**ARCHITECTURAL REVIEW COMMITTEE
STAFF REPORT
AGENDA ITEM NO. 1
February 16, 2006**

Request for a Use Permit to allow the construction of a new residence which exceeds the 44% lot coverage and the .55 floor area ratio guideline and a Parking Exception to allow tandem parking, per Sections 12.200.030.A.1, 12.200.030.A.2, and 12.200.080.C of the San Bruno Zoning Ordinance. Rommel Mendez (Applicant); Sunil Chand (Owner). **UP-05-68, PE-05-11**

**ARCHITECTURAL REVIEW COMMITTEE
STAFF REPORT
AGENDA ITEM NO. 2
February 16, 2006**

**ARCHITECTURAL REVIEW COMMITTEE
STAFF REPORT
AGENDA ITEM NO. 3
February 16, 2006**

ROOF PLAN
SCALE 1/8"=1'-0"

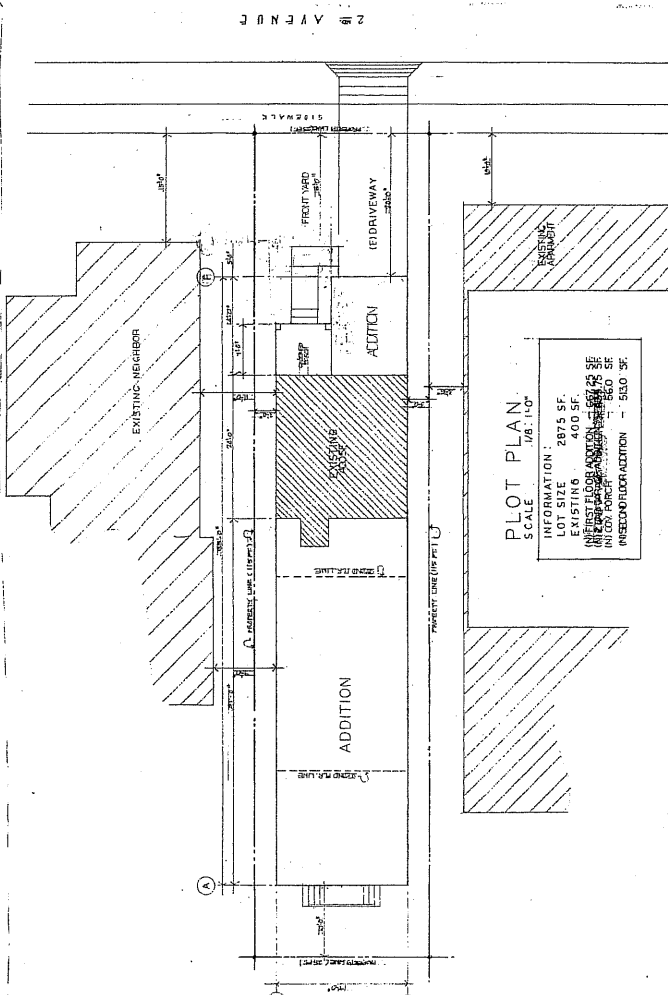
- Staff finds that the proposed two-story structure will blend in well with the existing neighborhood character since the design includes many attributes found within the neighborhood and is of the same size and mass as many neighboring homes.
- The replacement of an outdated small residence with a home more suitable to today's needs is consistent with the San Bruno Redevelopment Plan.
- The proposed structure will improve the parking situation since the existing residence does not contain any off-street parking and the proposal includes two off-street parking spaces.
- Applicant shall submit a color and material sample to the Planning Division prior to the Planning Commission meeting.
- Applicant shall add the height of the existing structure in the Planning Commission set of plans.

EXTERIOR ELEVATIONS
 114 SAN MATEO AVE., SAN GABRIEL, CA. LOT 19, BLOCK 19, APR 2000 S44 120

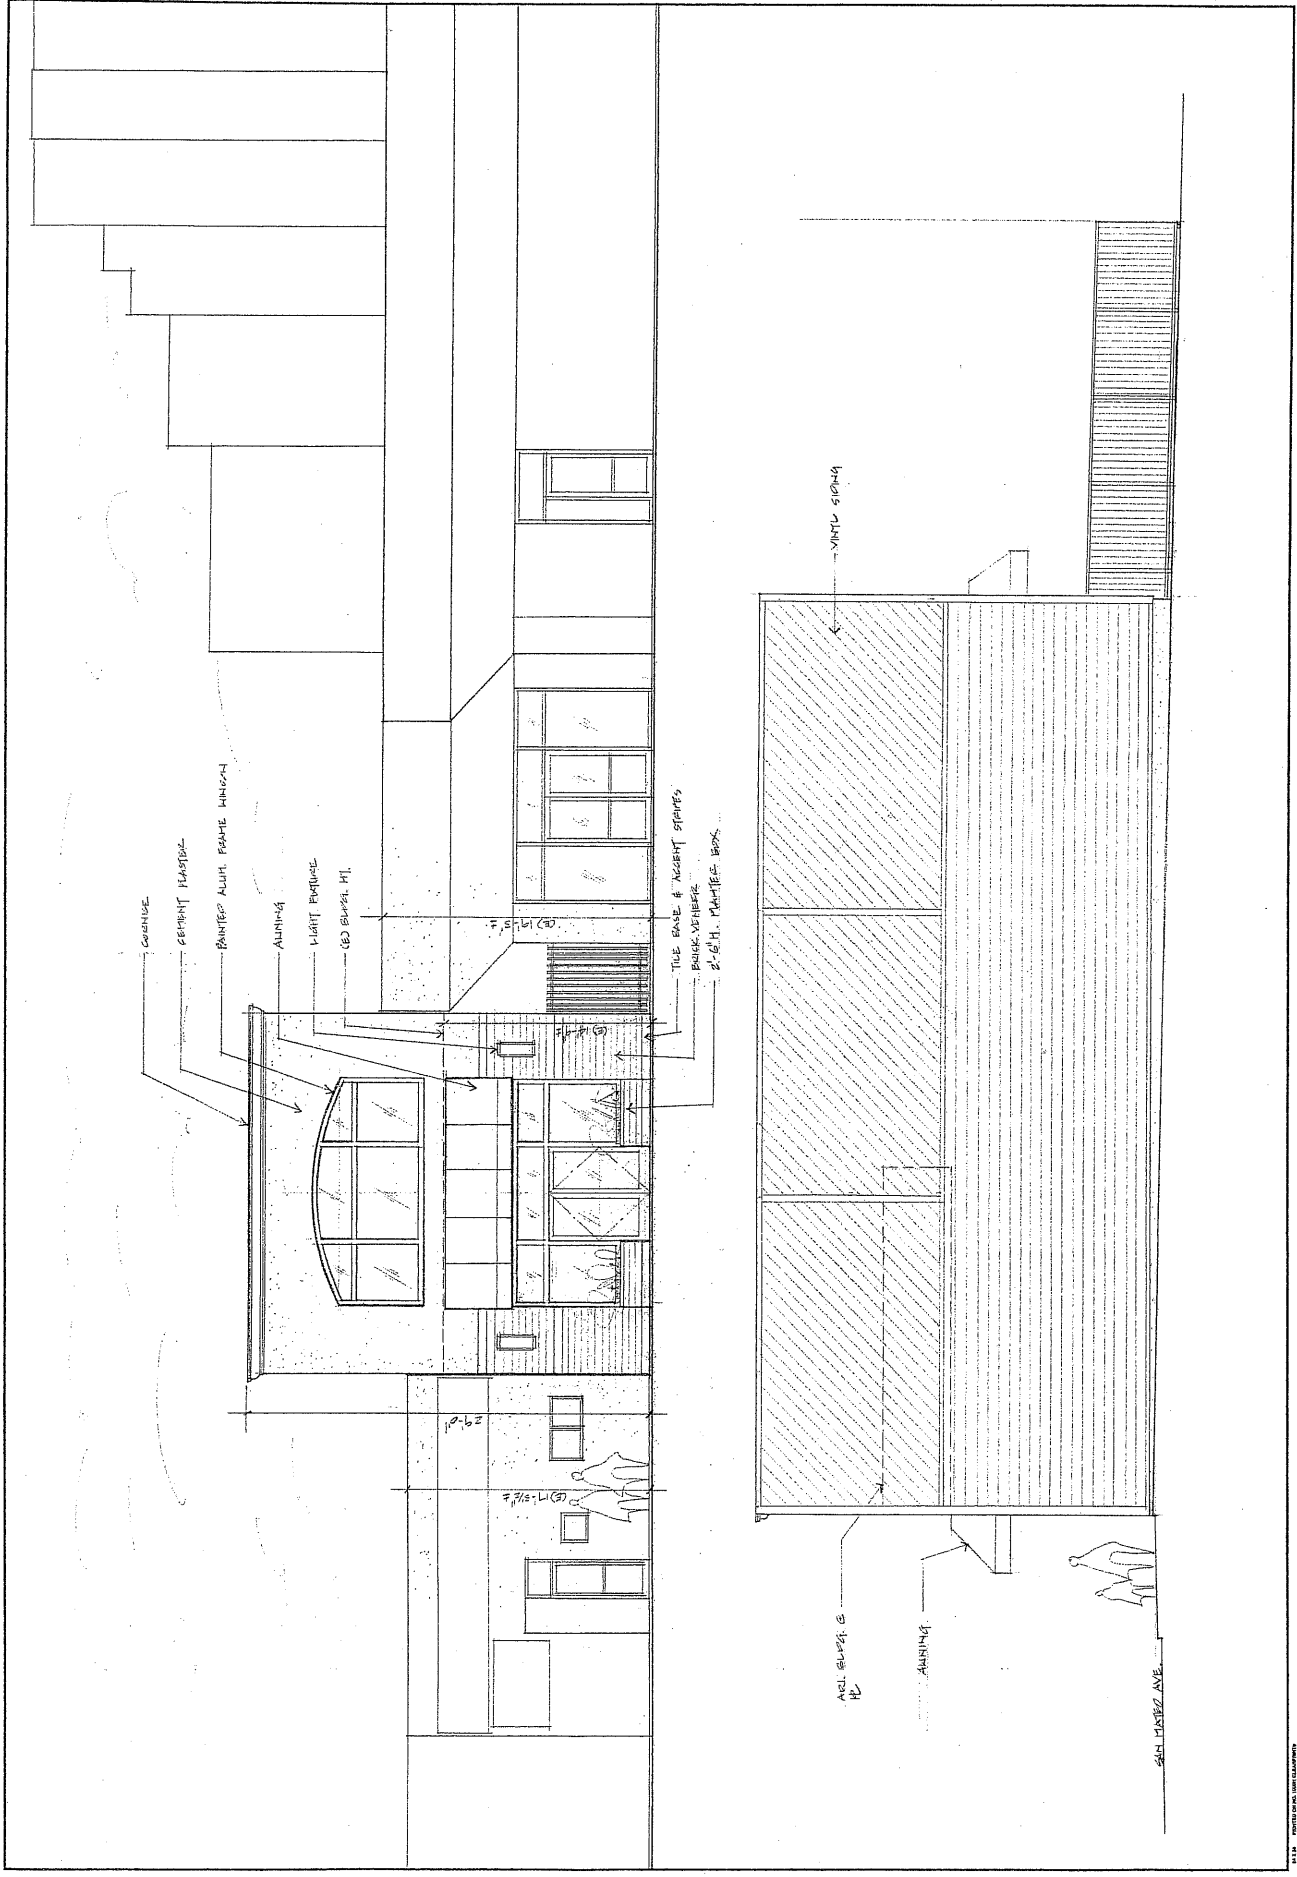
This project will be compatible with the character of Downtown San Bruno because the proposed façade maintains a 25-foot storefront avoiding a long expanse of inactive building frontage, and provides a suitable store entrance facing directly onto the street with large transparent display windows.

The building also includes several architectural features which are consistent with the Downtown Design Guidelines. The storefront is separated from the upper portion of the building by horizontal devices with a change in the finished material from brick veneer to cement plaster.

The other consistent features include a cornice, wide structural columns, and a tile base, adding an architectural treatment where the building meets the ground.

The applicant is also adding a clerestory window to create a pleasing scale to the storefront, and to add natural light to the interior as well as flower boxes to the storefront to add interest to the

11. Non-combustive material shall substitute proposed vinyl throughout.
